STAFF RECOMMENDATION 2217 29th Avenue South March 16, 2016

Application: New construction – infill and outbuilding; Setback determination
District: Hillsboro-West End Neighborhood Conservation Zoning Overlay
Council District: 18
Map and Parcel Number: 10414009300
Applicant: Emily Johns, Aspen Construction
Project Lead: Melissa Sajid, Melissa.sajid@nashville.gov

Description of Project: The applicant proposes to construct a new residence and outbuilding, which is not to be used as a detached accessory dwelling unit. This request also includes a left-side setback determination of four feet and three inches (4' 3").

29TH AVE LOTS
Scale: 1/32" = 1'-0"

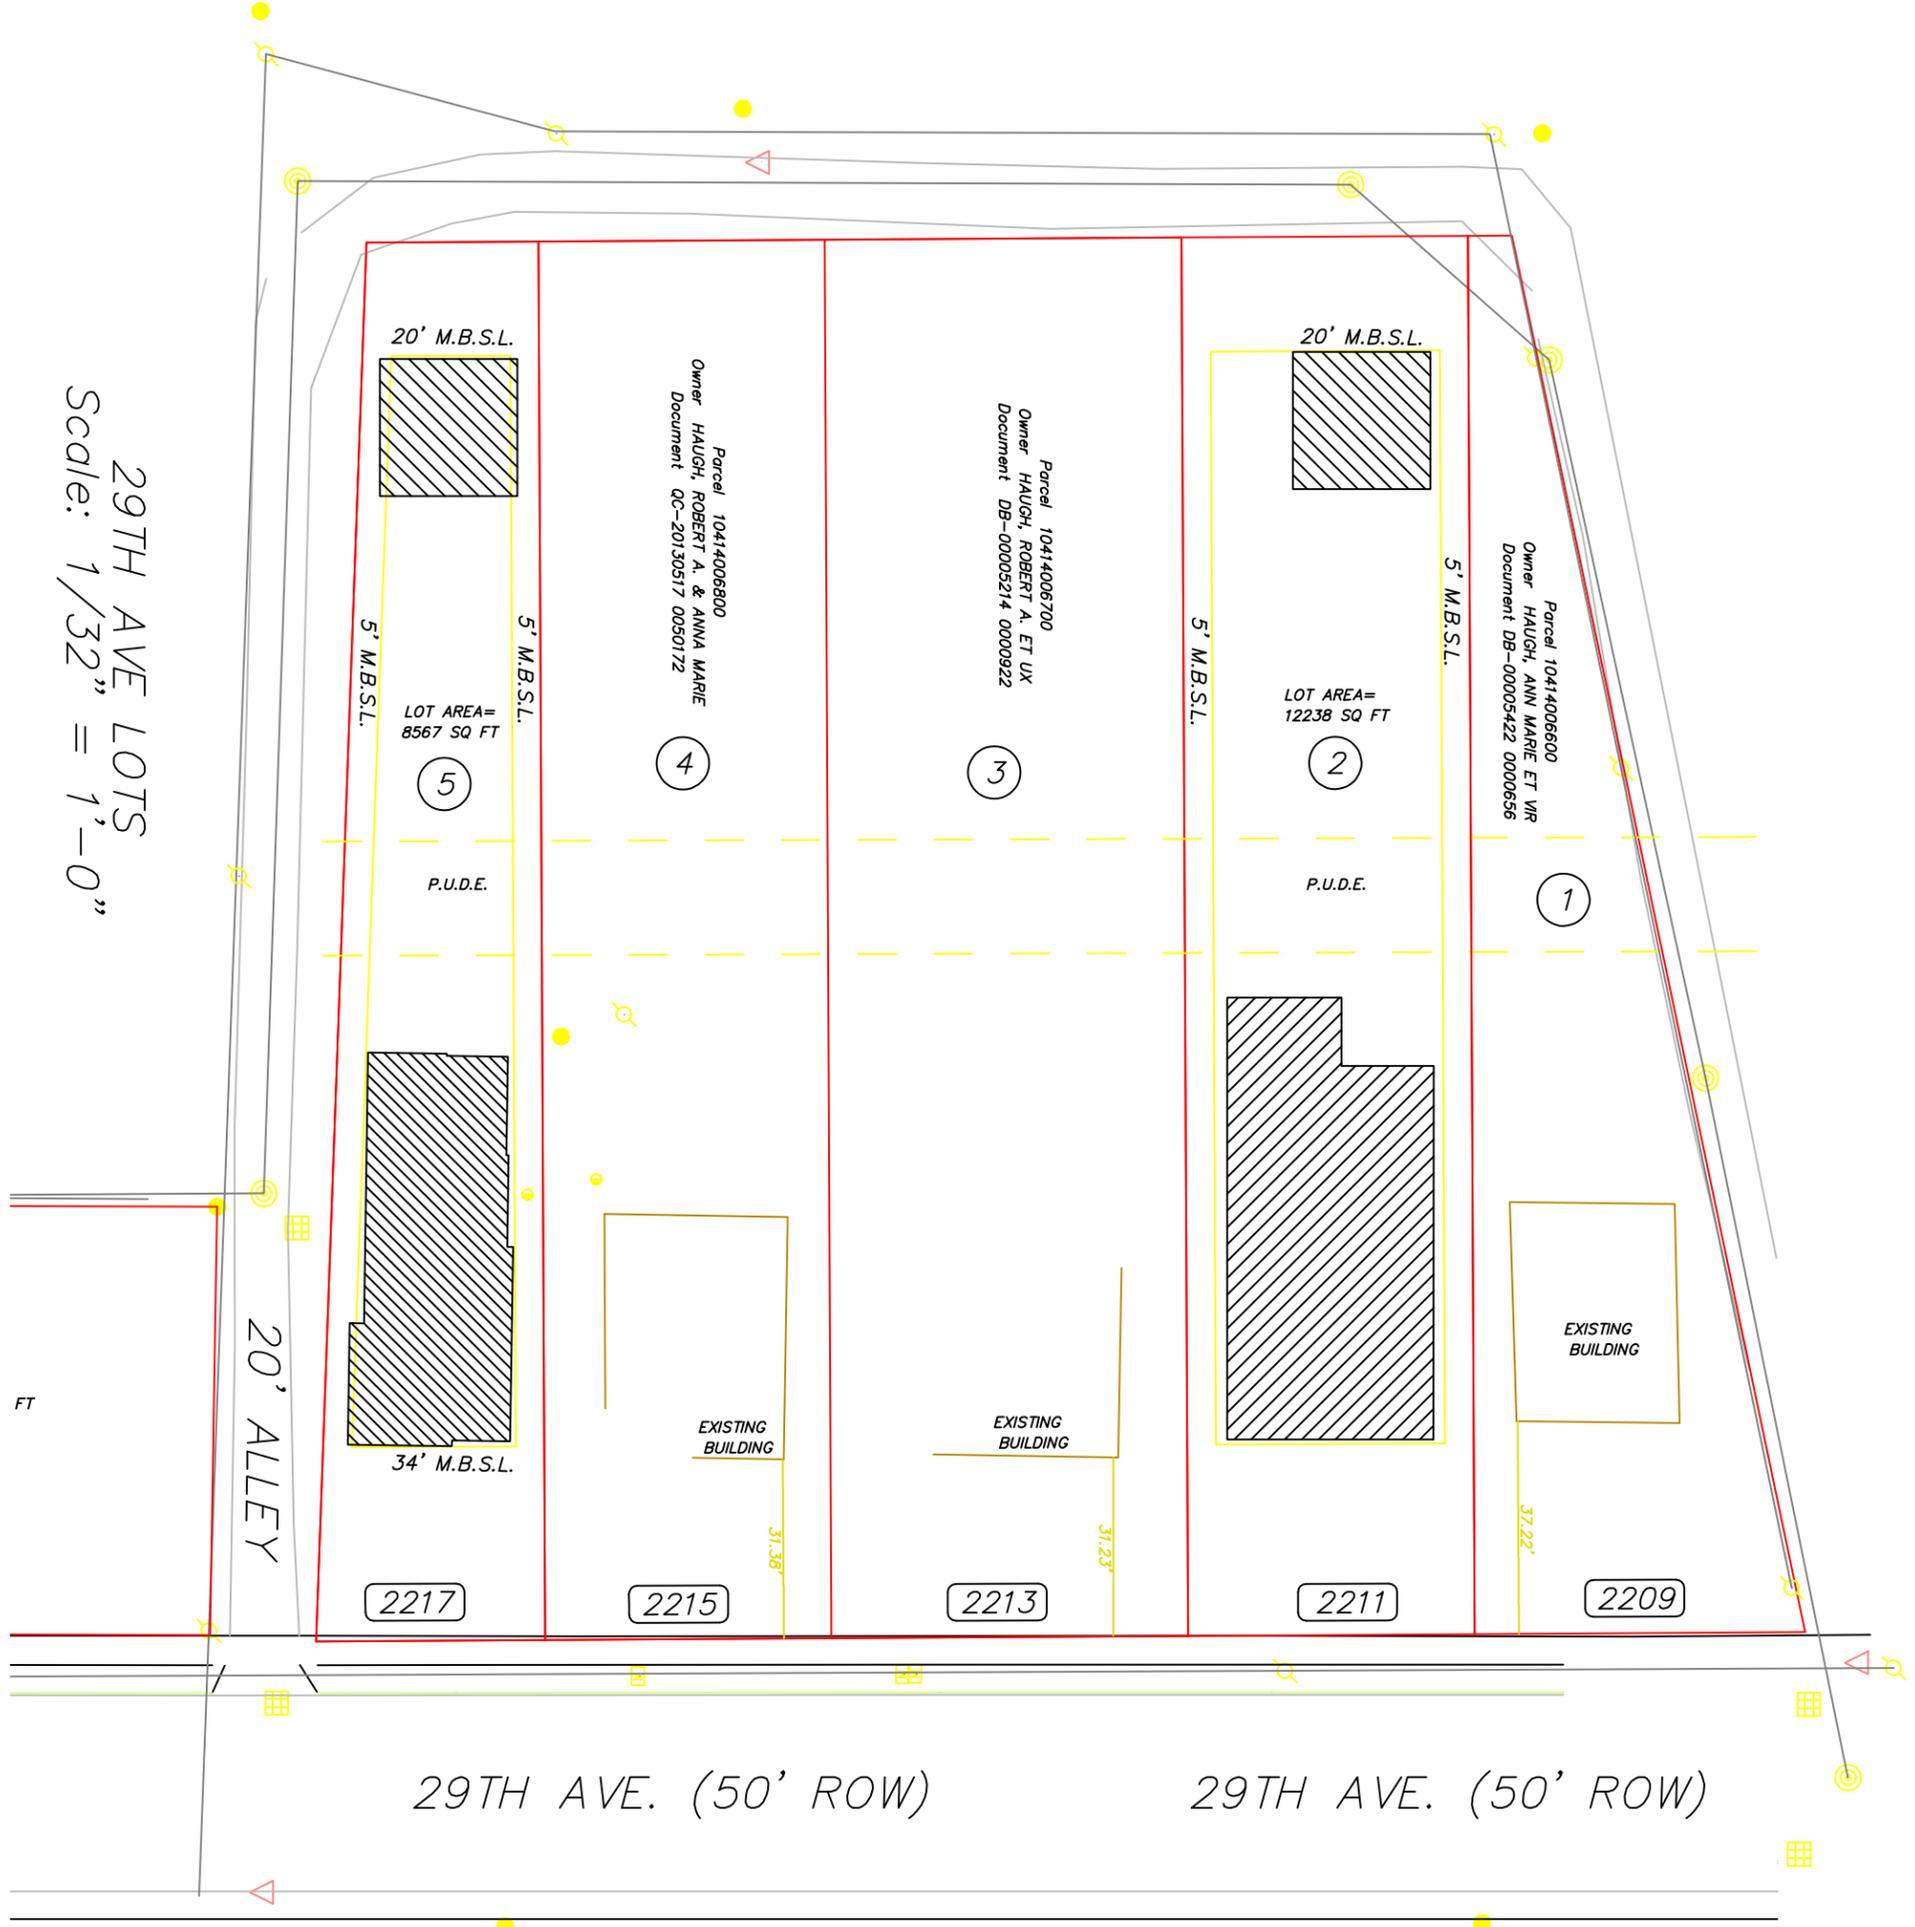
Setback & Rhythm of Spacing: The infill will be located approximately thirty-four feet (34') from the front property line and will include the front stoop, which has a depth of four feet, four inches (4' 4"). The design guidelines recommend a depth of at least six feet (6') minimum for a porch, but staff finds that the proposed depth is appropriate for a stoop, which is seen on historic homes in the vicinity. The site is adjacent to an alley on the left side, and the contributing house to the right has a front setback of approximately thirty-one feet, four inches (31' 4"), which includes the front porch. Staff finds that the proposed front setback is appropriate since there is no porch on the proposed infill and the lot is bound by an alley to the left.

The side setbacks will be approximately four feet, three inches (4' 3") on the left side and five feet (5') on the right. The request includes a side setback determination for the left side as the minimum setback required by the zoning is five feet (5'). Staff finds that the proposed side setbacks are appropriate as the lot is narrower than other lots in the vicinity, and the reduced left side setback allows for the building to be wider at the front, which helps maintain the rhythm of the street. The lot is forty feet (40') wide at the street and narrows to thirty feet (30') at the rear property line. In addition, the left side is adjacent to an existing alley, and there is no building just beyond the alley that is oriented to 29th Avenue South, so the setback reduction should not have a significant impact on adjacent property.

- The HVAC be located behind the house or on either side, beyond the mid-point of the house;
- A walkway from the front stoop to the existing public sidewalk be incorporated;

PLOTTED:
Friday, March 4, 2016
DRAWN: CD Plans
SHEET NUMBER:
3 OF 6

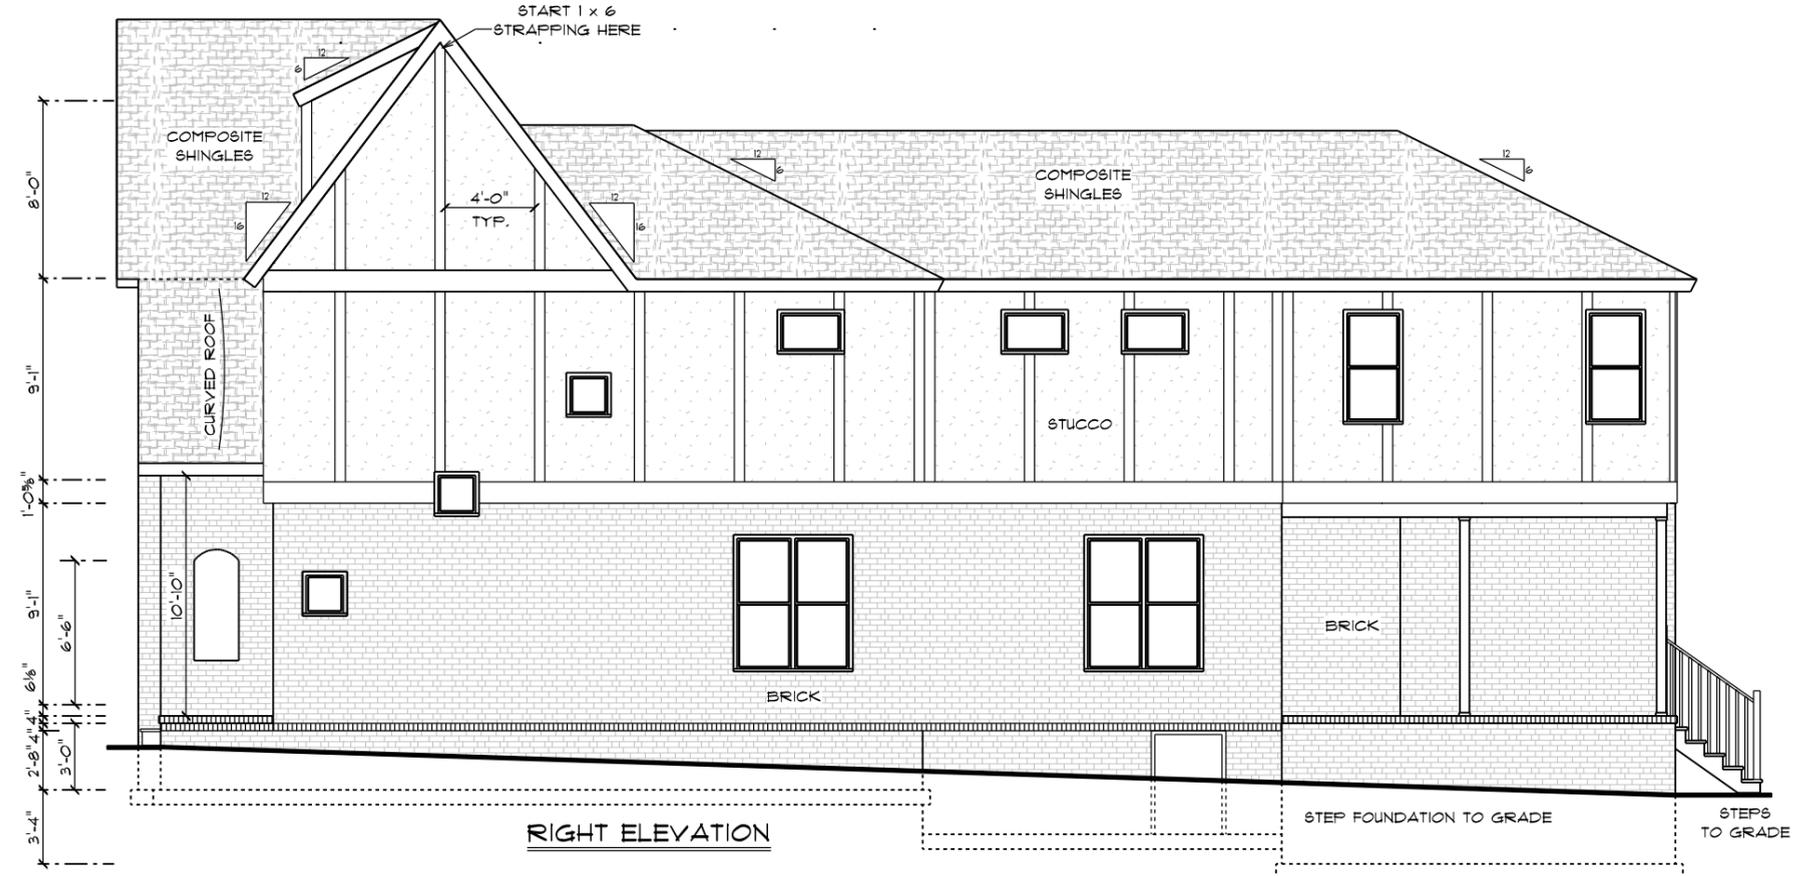
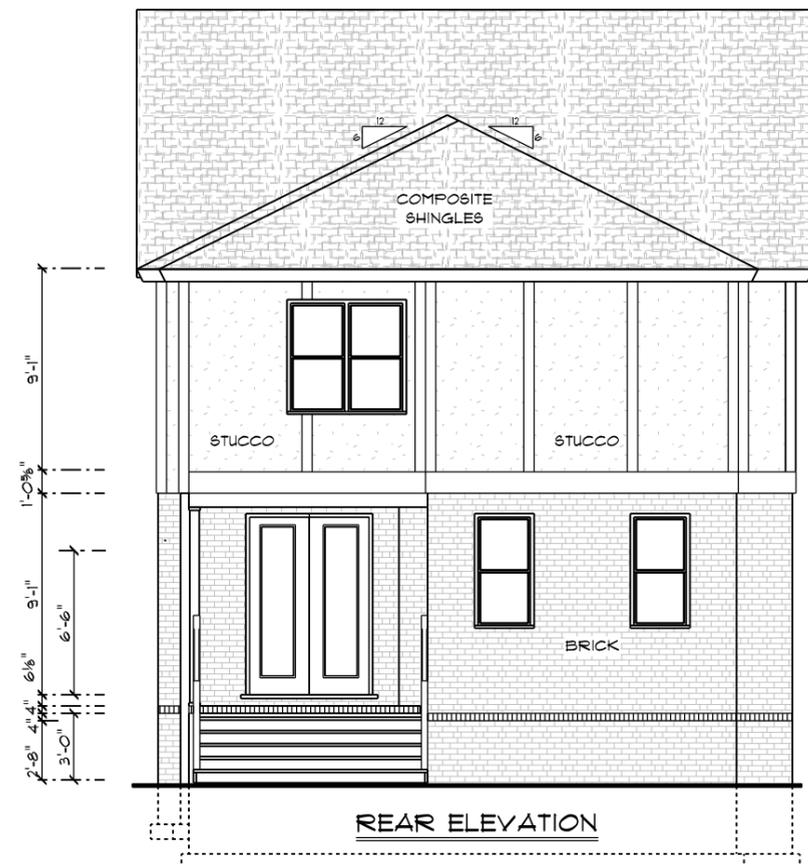
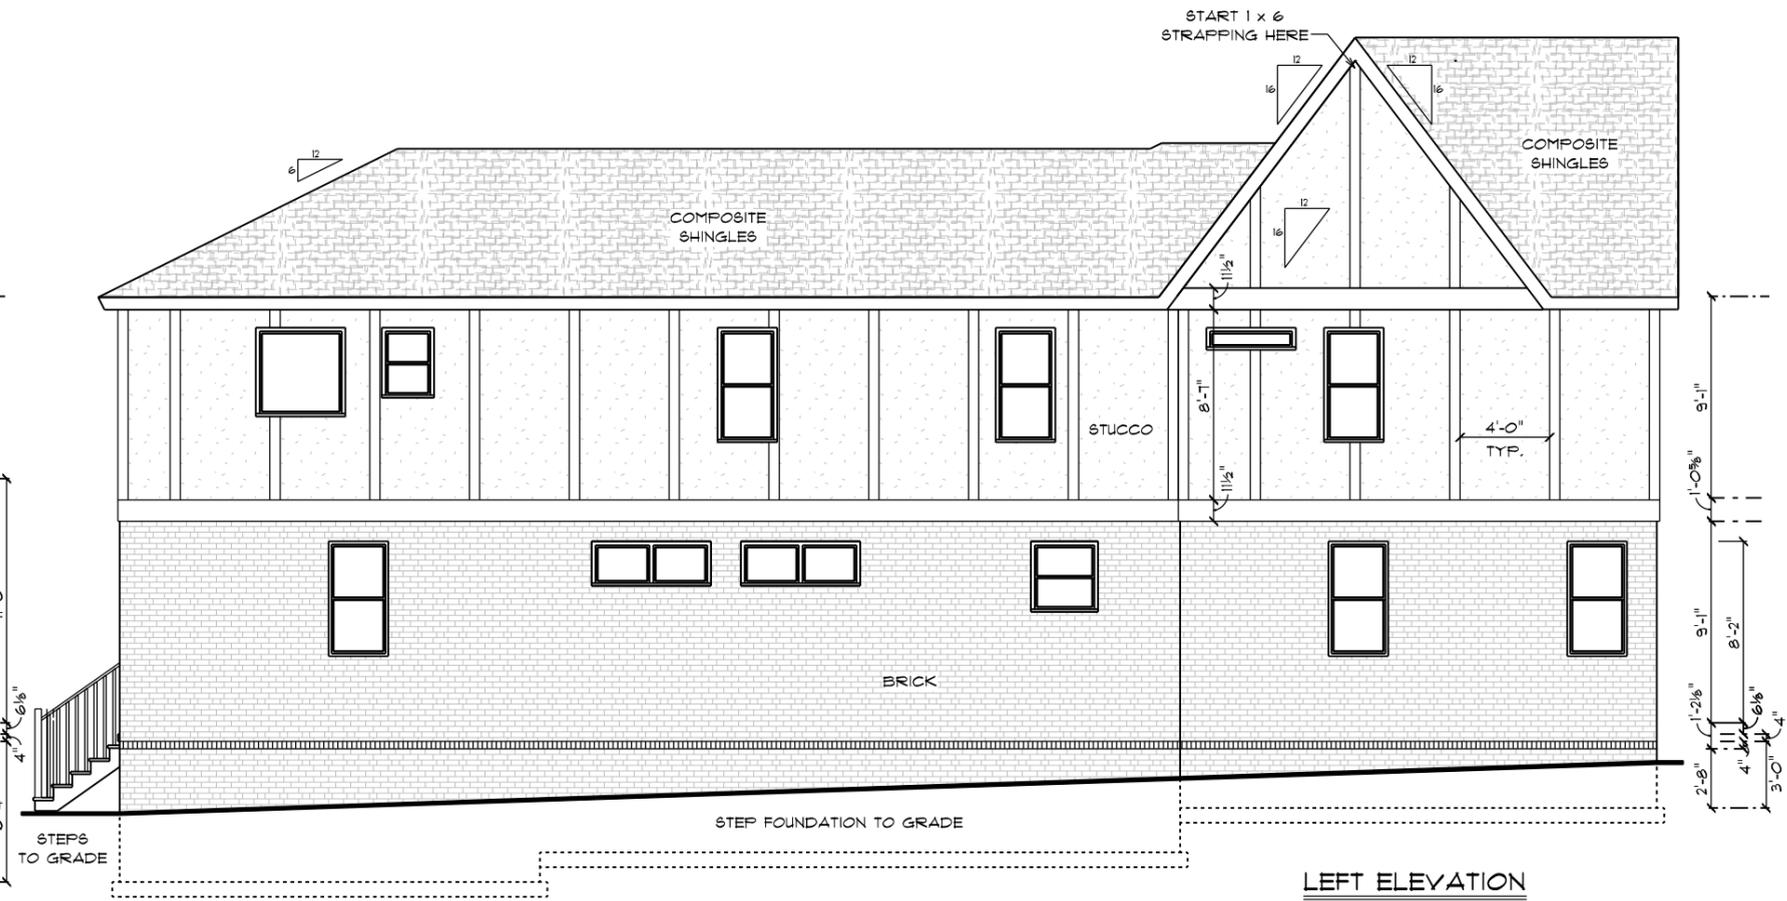
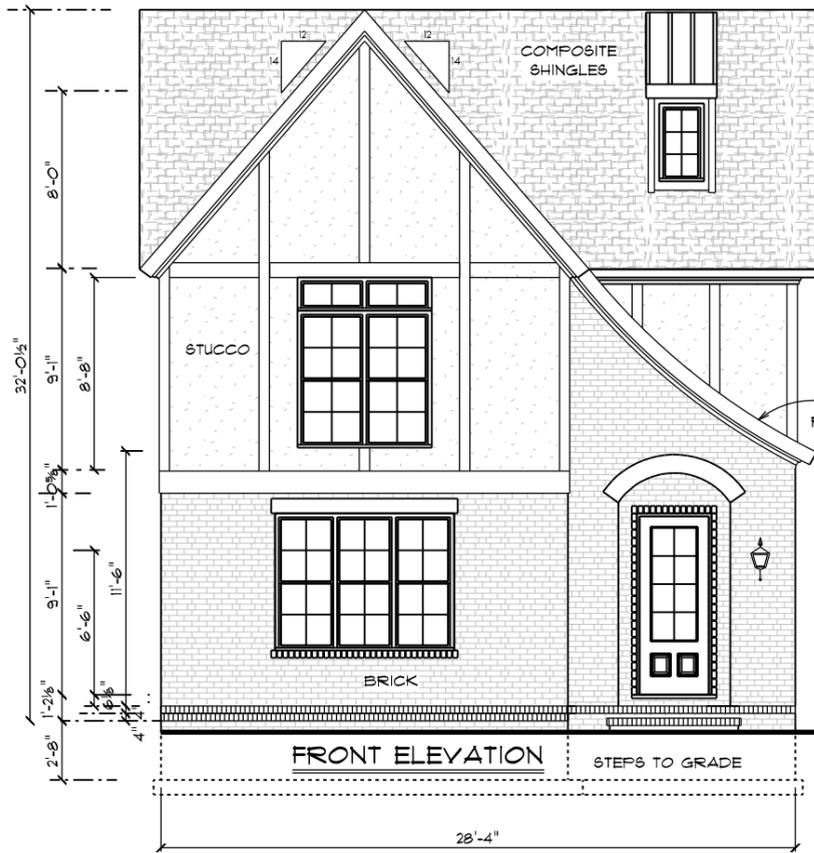
Roof Shape: The roof will be side-gabled with pitches of 16:12, 14:12, and 6:12 and includes a dormer on the front façade that will be set off the ridge and inset at least two feet (2') from the wall below. The front dormer is out of scale, and staff recommends one that sits off the ridge by at least one foot (1') and that is approximately two feet (2') wider with either a wider window or two narrow windows. Staff finds that, with the conditions recommended, the proposed roof forms can be compatible with those of surrounding historic homes and that the infill meets Section II.B.5. of the design guidelines.

Rhythm and Proportion of Openings: The windows on the front and rear of the house will be generally twice as tall as they are wide, as seen historically. However, the side façades incorporate three square windows that create a stair-step rhythm on the right side and three horizontal windows on each side that do not meet the design guidelines in terms of rhythm and proportion. It is unclear as to whether the paired windows incorporate four to six inch (4"-6") mullions, as seen historically. Staff recommends conditions that the windows on the side façades be generally twice as tall as they are wide; that the paired windows incorporate four to six inch (4"-6") mullions between them; the horizontal windows be twice as tall as they are wide and that there be just one square window in the stairwell. Staff finds that, with the proposed conditions, the proposal can meet Section II.B.7. of the design guidelines.

- The front dormer be set off the ridge by at least one foot (1') and that it be approximately two feet (2') wider with either a wider window or two narrow windows;

- The windows on the side façades be generally twice as tall as they are wide;
- The horizontal windows be twice as tall as they are wide;
- Only one square window be located in the stairwell; and

- Paired windows incorporate four to six inch (4"-6") mullions between them.
